Final Interchange Justification Report

Interstate 95 and Matanzas Woods Parkway

Flagler County

December 2010
Revised February 2011

I-95 and Matanzas Woods Parkway Interchange Justification Report
Build - Year 2025 and Year 2035 Intersection Geometry
 Figure 7-22

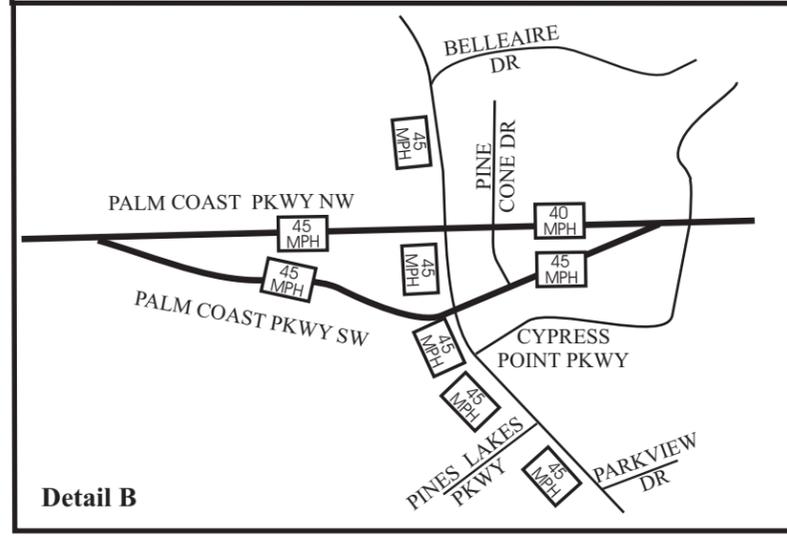
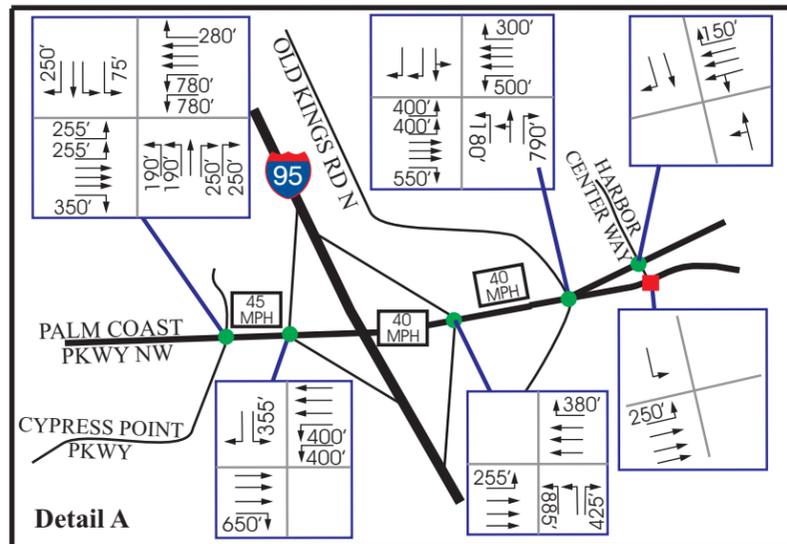
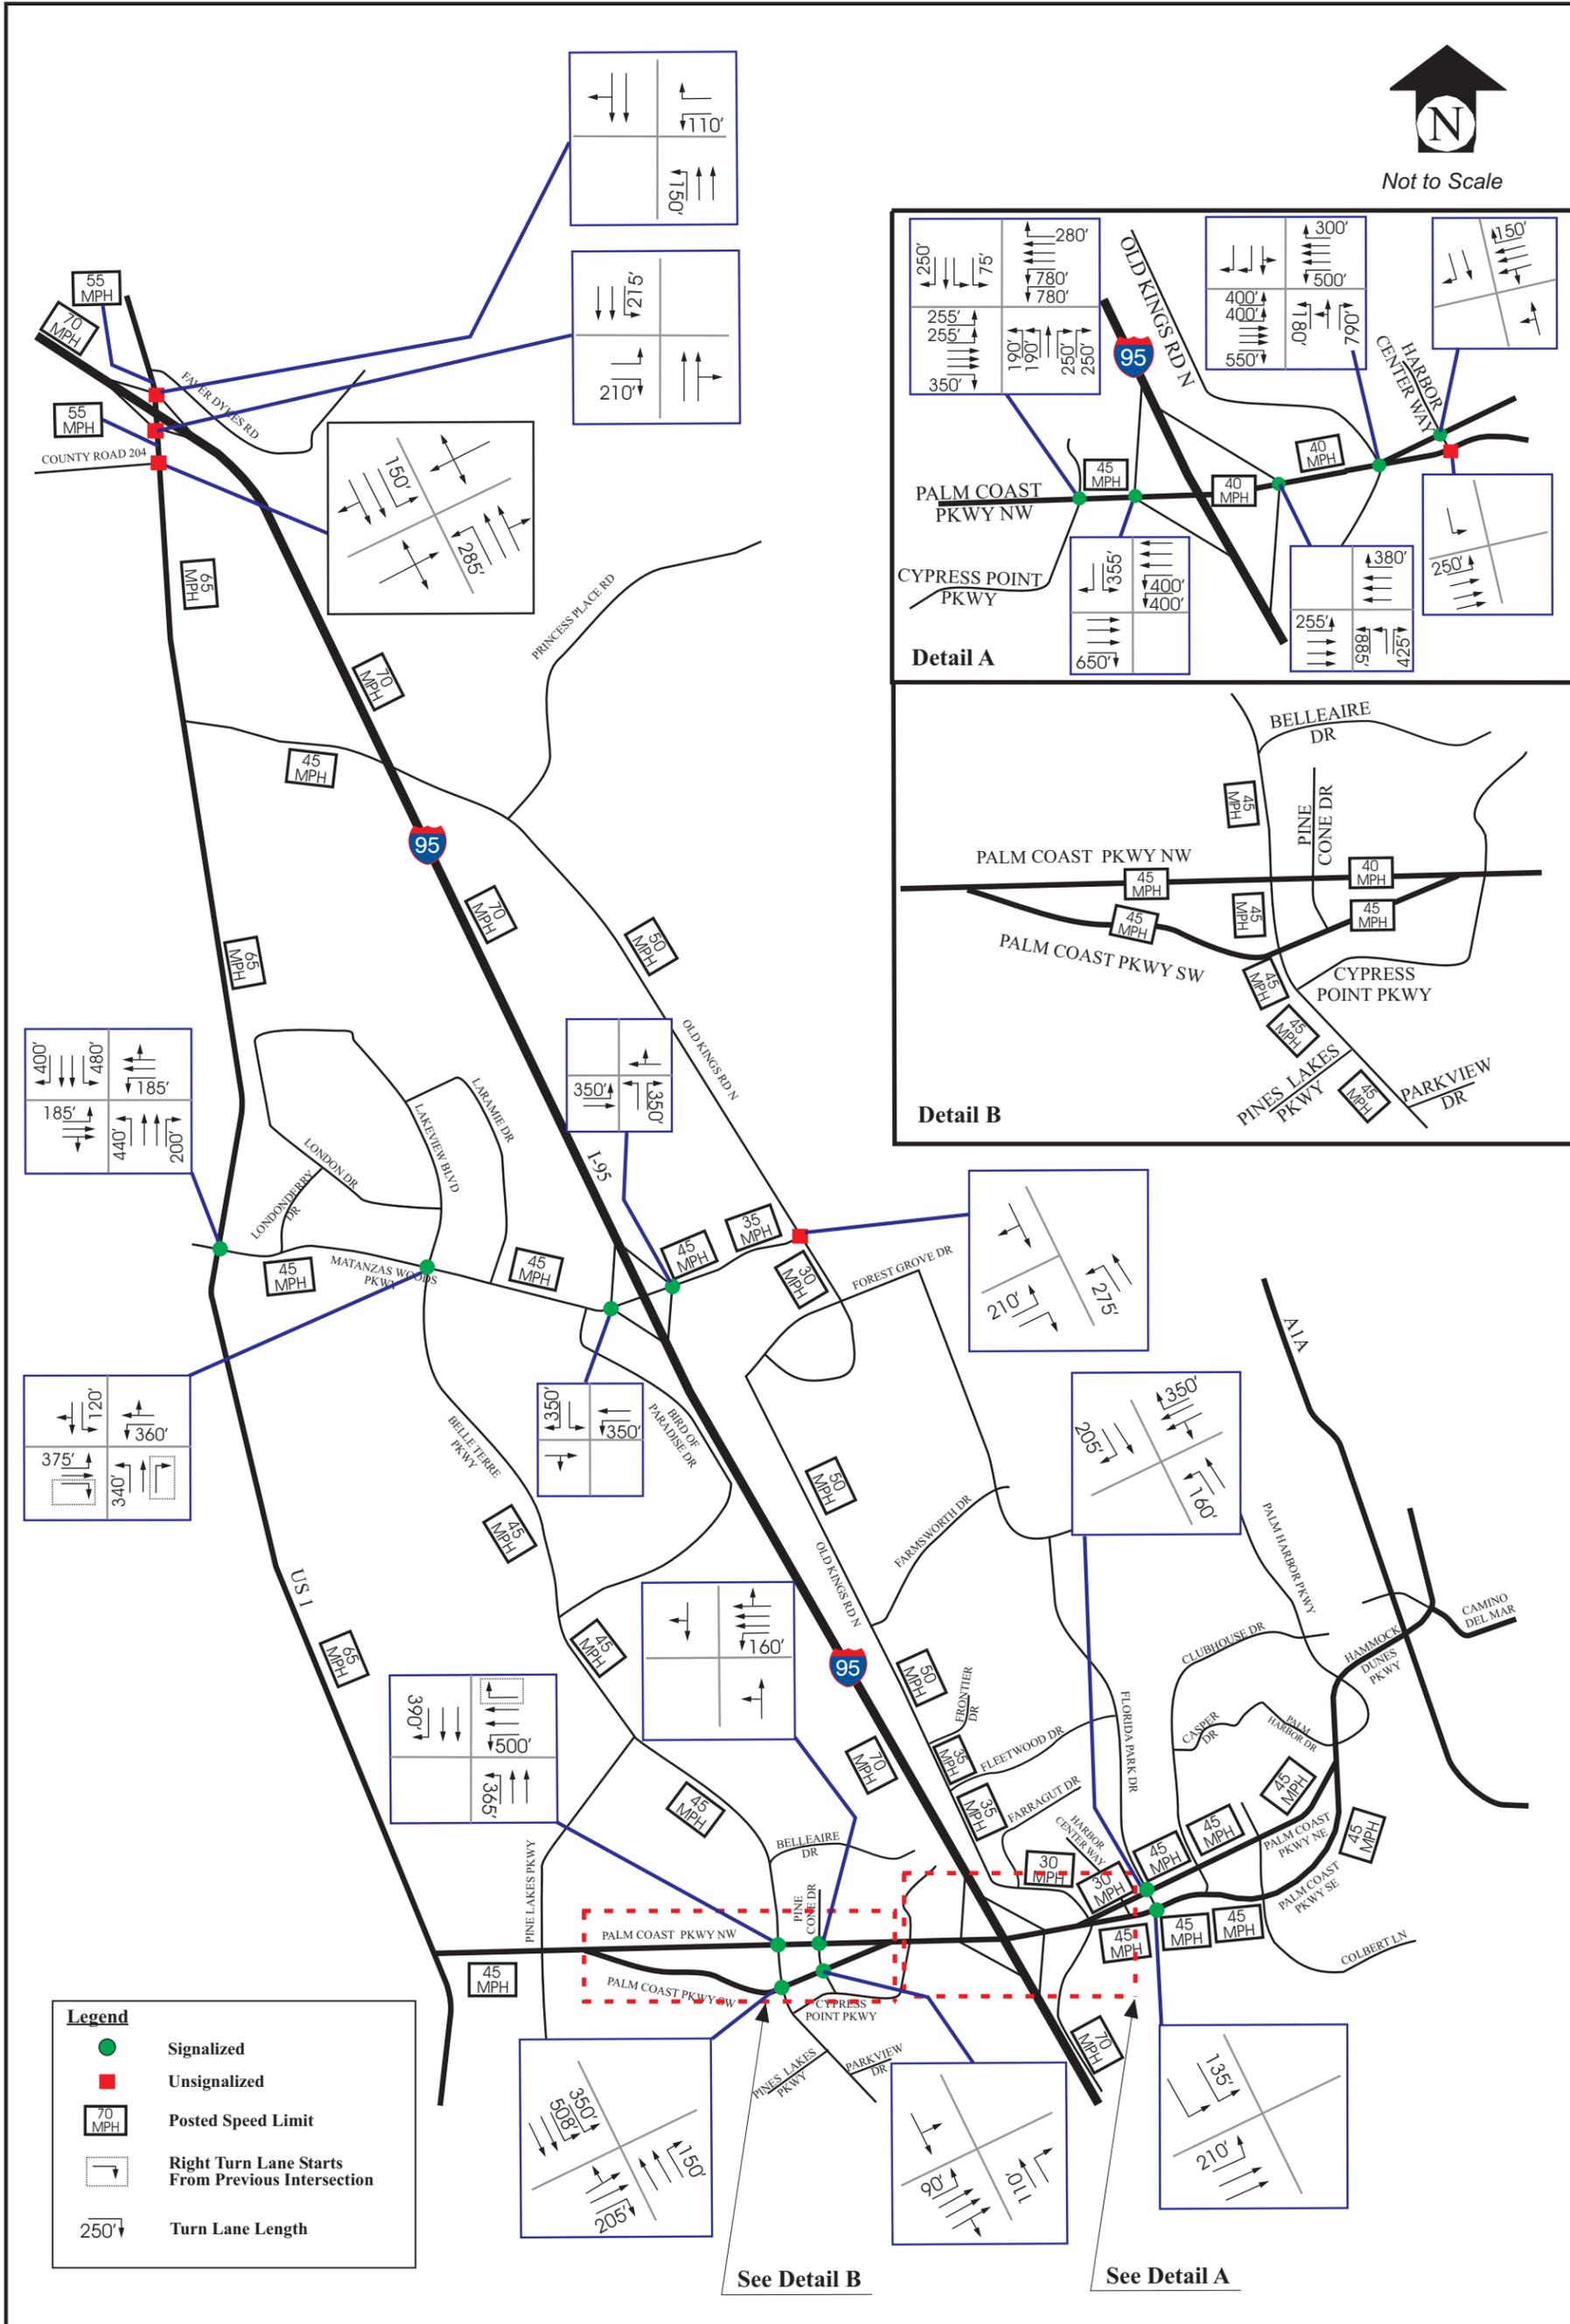
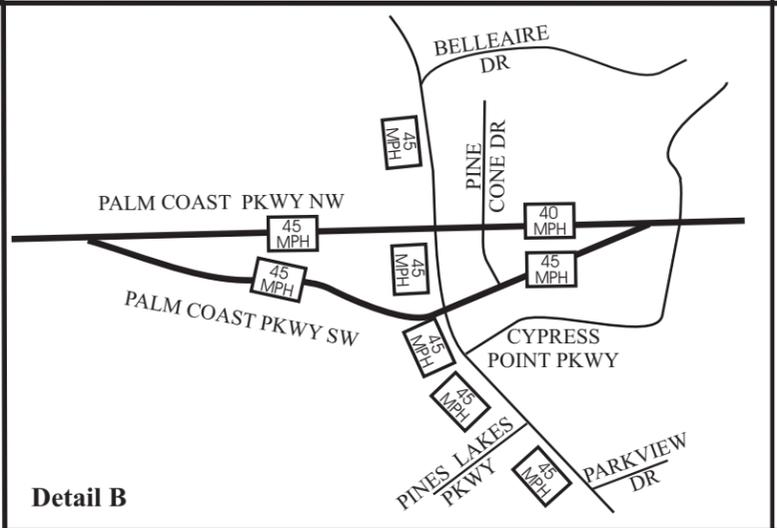
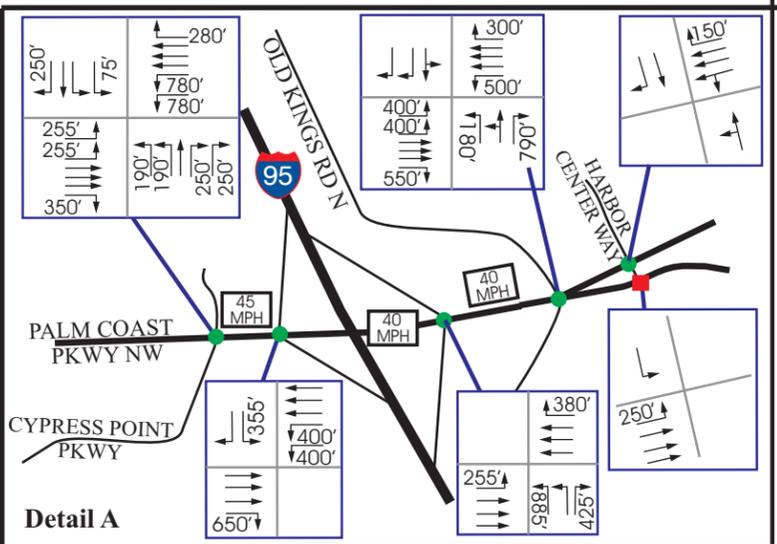
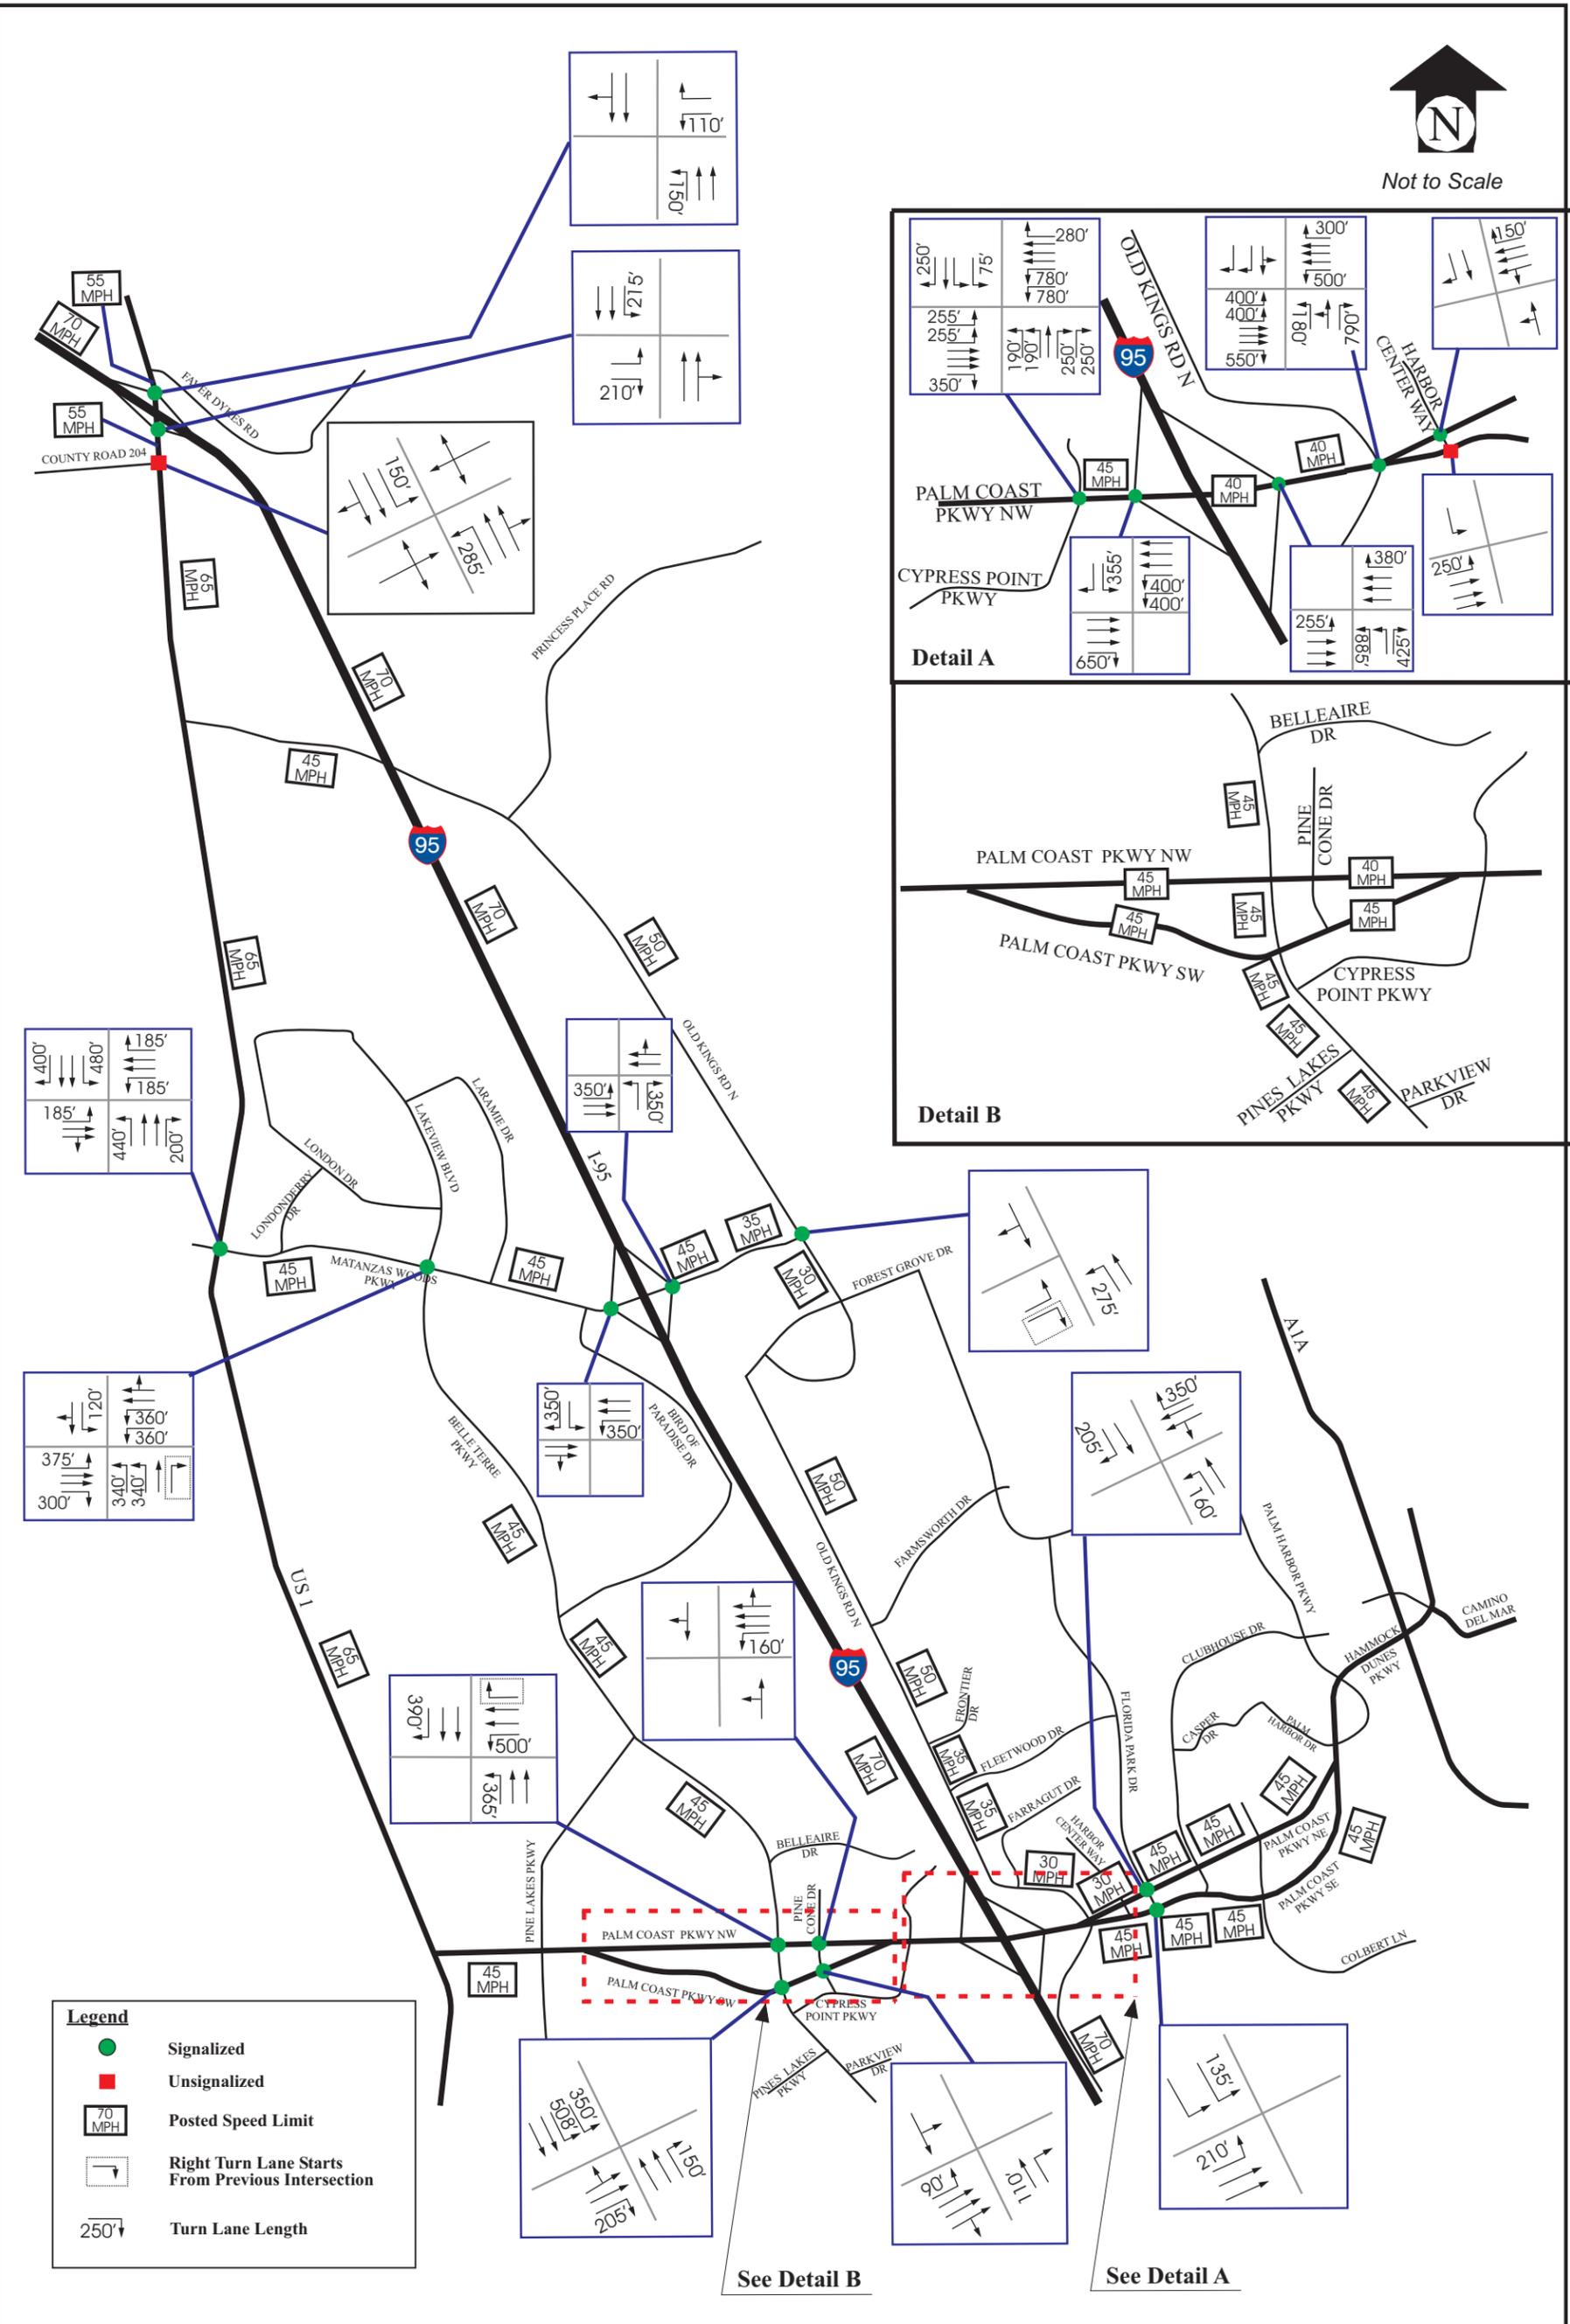
Comment 10: The CFRPM 4.5 model shows Belle Terre as 4 lanes south of Matanzas Woods Parkway in year 2012 and year 2025. But figures 23-26 in the document show Belle Terre as 2 lanes for this section. The model shows Matanzas Parkway as 4 lanes in year 2025. But figure 25 in the document shows Matanzas as 2 lanes under No-Build condition. The laneage shown in the cost feasible model should be incorporated in the No-Build and Build scenarios. Please check and revise the report and analyses.

Response 10a: The City's Belle Terre Parkway Four Laning project indicates that Belle Terre is a 4-lane road south of Matanzas Woods Parkway for all future years. In the figures 23-26, the northbound approach has two full lanes that are delineated as one through lane and the other becomes one exclusive right turn lane. Belle Terre Parkway's southbound approach has one full lane which is a shared through/right turn lane. The southbound departure is two lanes. Each approach has a separate left turn pocket. The figures only show entering laneage but not departure laneage, and are therefore correct. Figures 23-26 are now Figures 7-19 through 7-22.
